Chicago O'Hare International Airport Terminal Area Plan and AirTraffic Actions Environmental Assessment

Terminal Area Plan and Air Traffic Actions Environmental Assessment at Chicago O'Hare International Airport
10000 W. O'Hare Ave.
SHPO Log #003042921

PLAN REVIEW TO BE INCLUDED IN CHICAGO O'HARE INTERNATIONAL AIRPORT TERMINAL AREA PLAN AND AIR TRAFFIC CONTROL ACTIONS ENVIRONMENTAL ASSESSMENT COMMITMENTS

Proposed Upper/Departures Level Plan

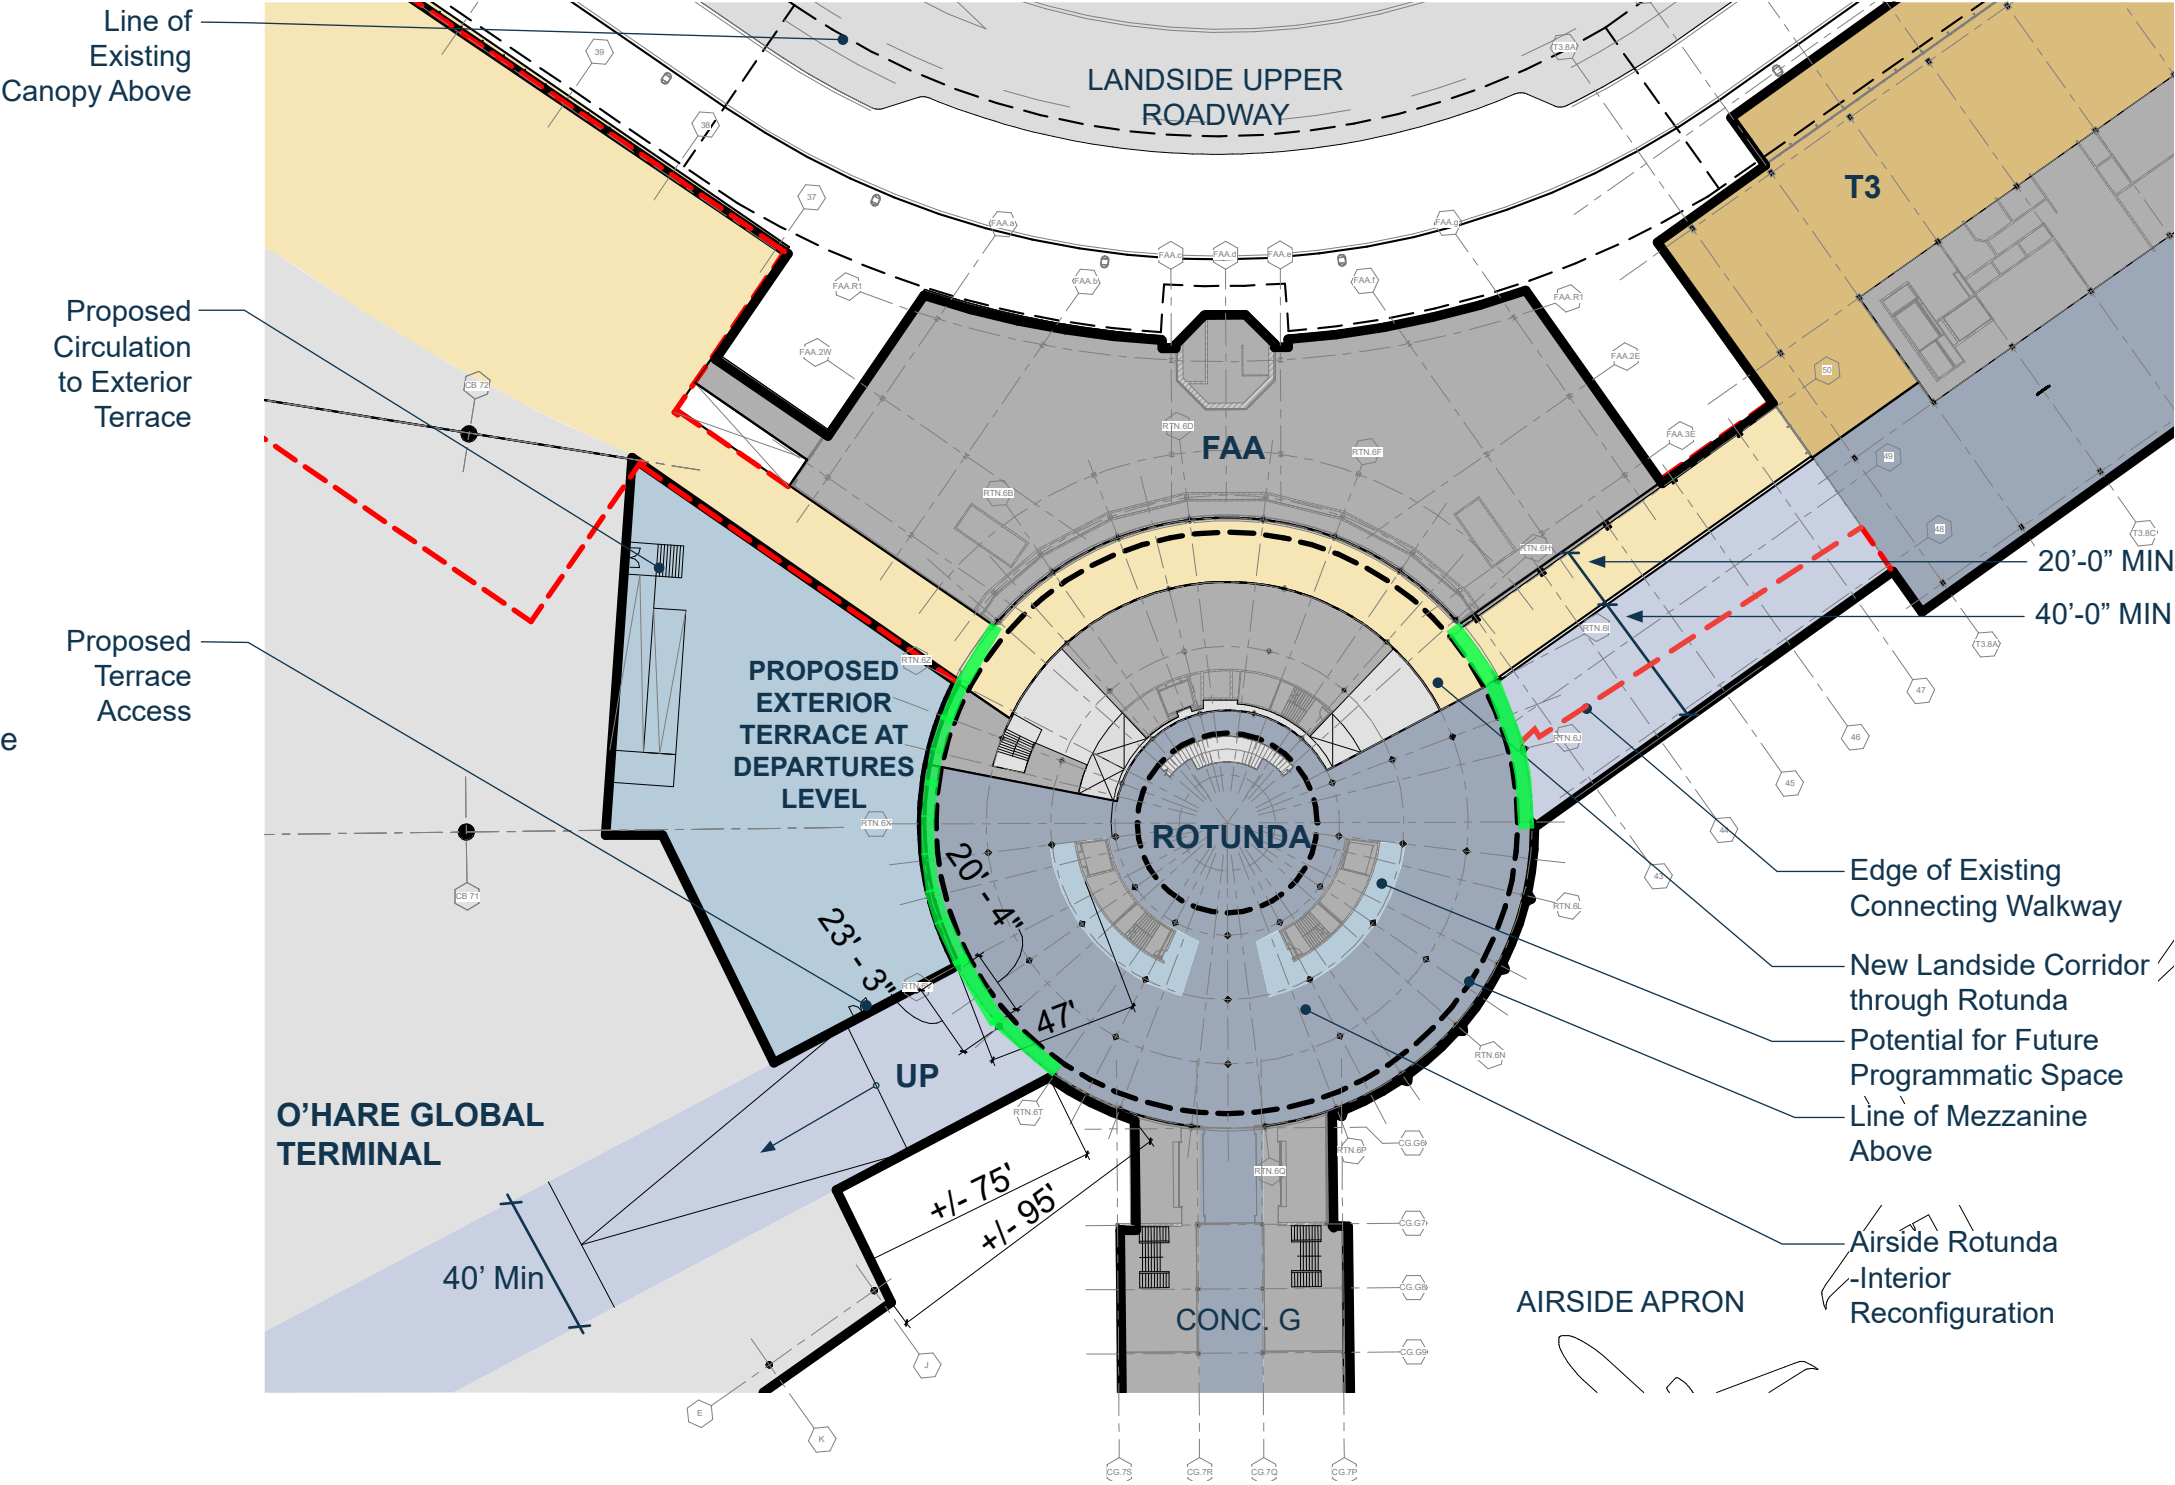
Note: Plans are also needed for removal of non-original concessions and offices on the concourse level and the outdoor terrace space between the Rotunda and the O'Hare Global Terminal
